# 970 DENNY

WEST DRB RECOMMENDATION MEETING

08.19.2015 | 14-062 | DPD #3018935

## MASSING OPTION 3 – PREFERRED

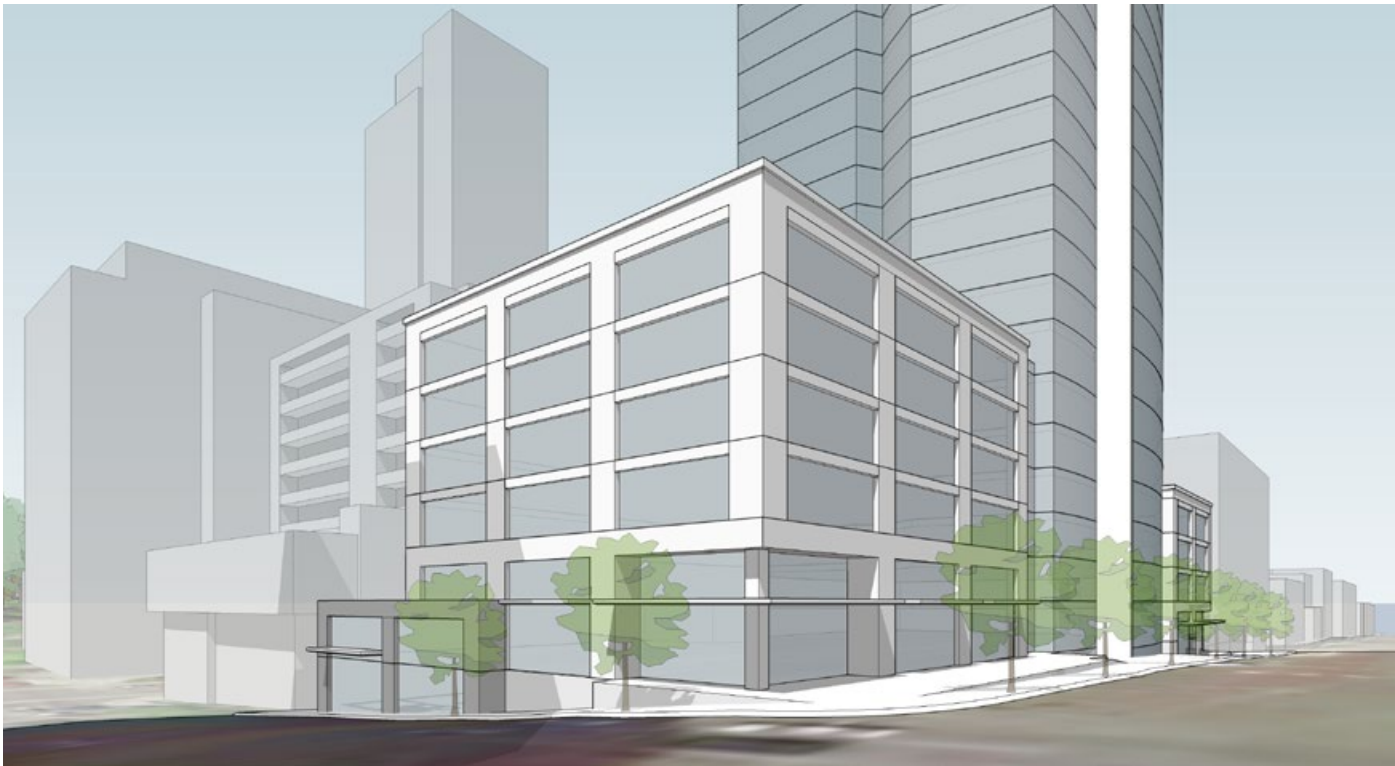
“The Board strongly endorsed the north tower placement for this prominent and tall form, as it creates a south roof terrace and better scale along Denny (EDG booklet pages 23/24). The Board also endorsed the preferred massing option 3, with some aspects at the lower levels along Terry Avenue of option 2 being desirable.” – #3018935 EDG Report 2.18.15

Design proposal at EDG

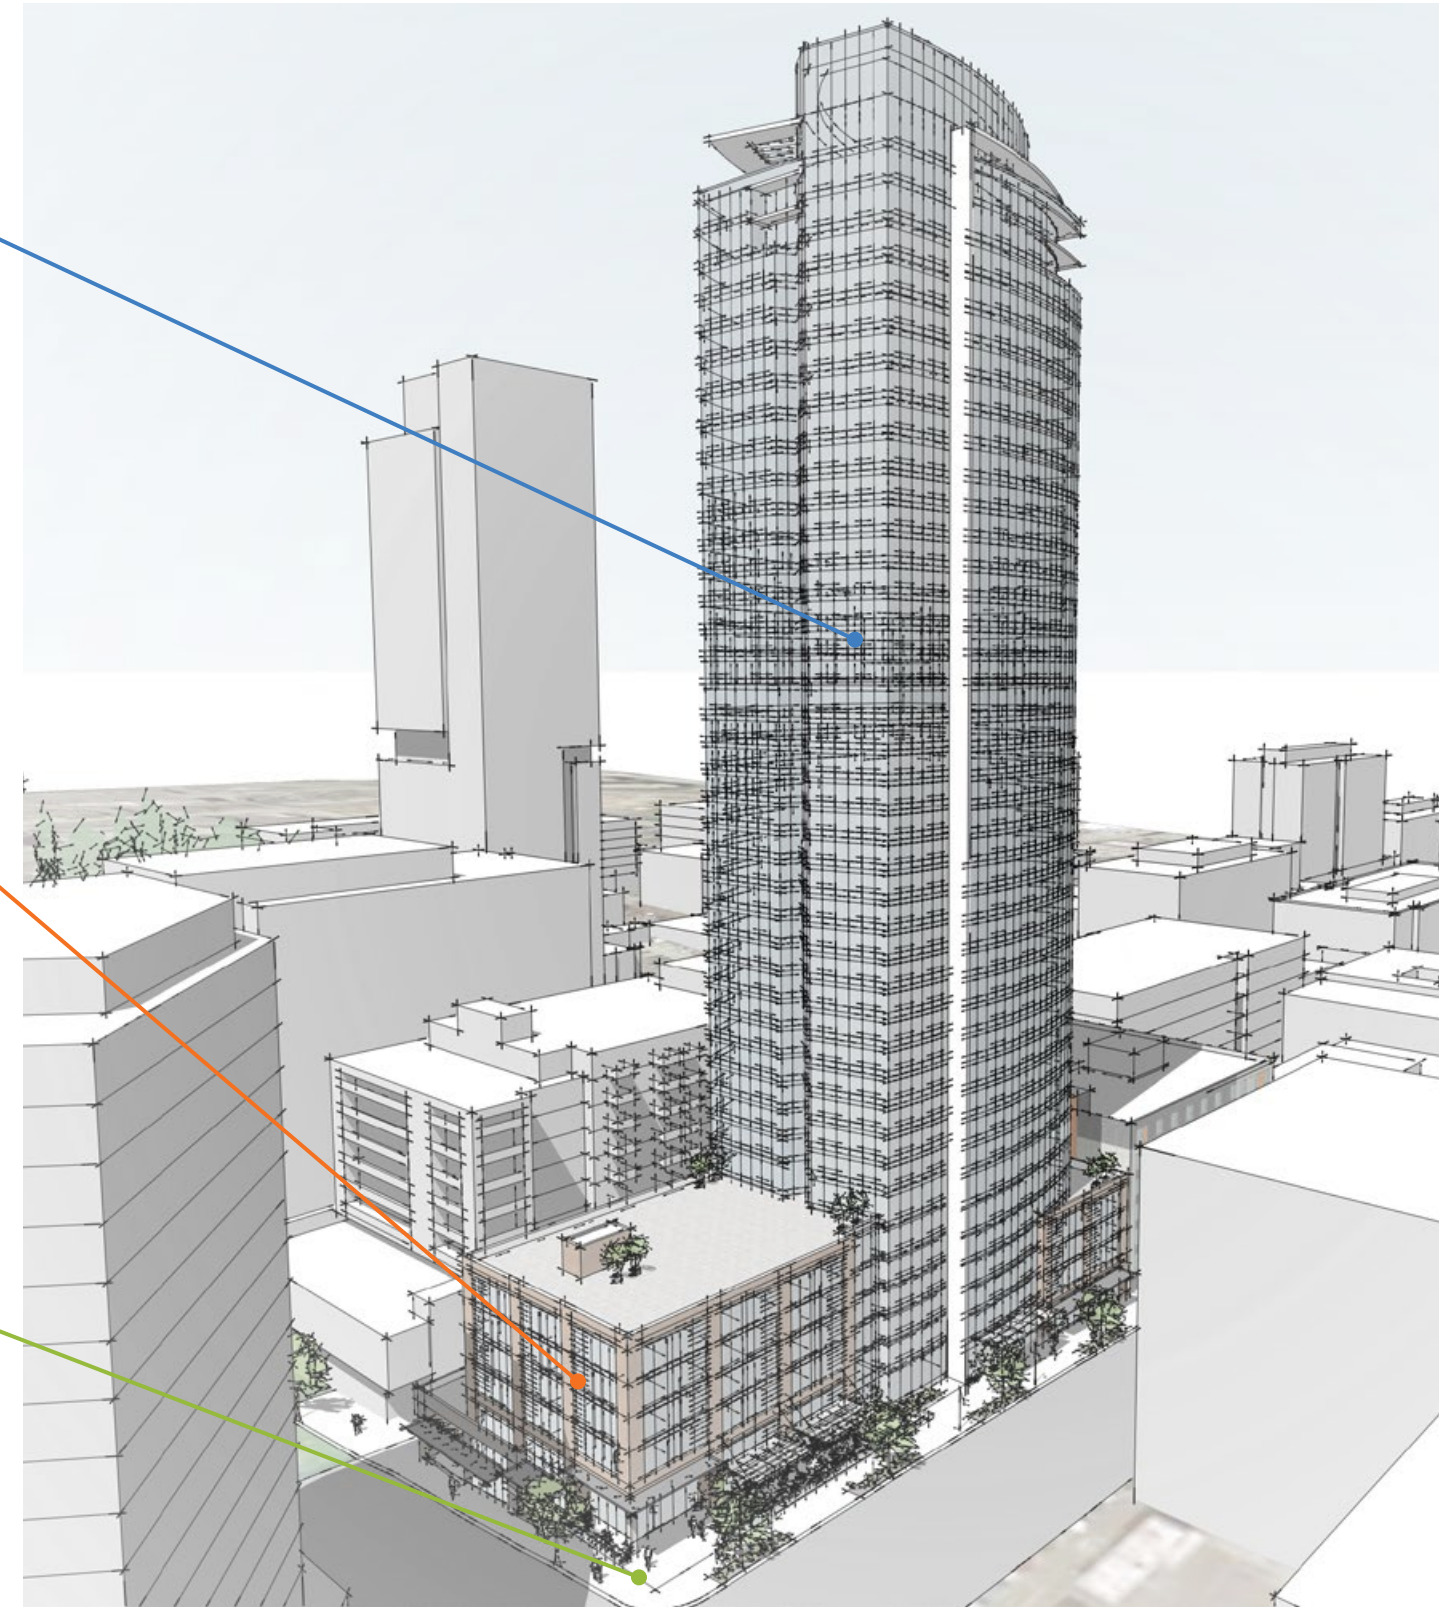
- Questioned how the tower expression meets the street and interacts with the 'industrial' base along Terry.
- Board agreed that the tower lacked intermediate scale and plane shifts at the southeast base of the tower to delineate entry.
- Board encouraged four elevations to be carefully composed as they will be visible from a distance, and not equal on each side, responding to different factors for each orientation.
- Complete explanation of sustainable strategies

- Agreed the north 'industrial' mass should extend further south to better balance the street facade.
- Board encouraged to not simply mimic historic architecture, but to interpret and distill key material and composition for a modern building.
- Board encouraged further exploration of the corner and upper podium for elements that acknowledge the pivotal Terry hinge at Denny.
- Board endorsed high activation of the south podium rooftop.

- Dock on Southeast corner encroached too far onto pedestrian sidewalk.
- Denny Way streetscape plan suggests a 6ft setback inside the property line, with paved area inside this having canopies for pedestrian protection.
- The board agreed the pedestrian volumes along Denny warrant the 10ft paved zone.
- Encouraged to work with SDOT on a crosswalk across Denny in the SIP plans.
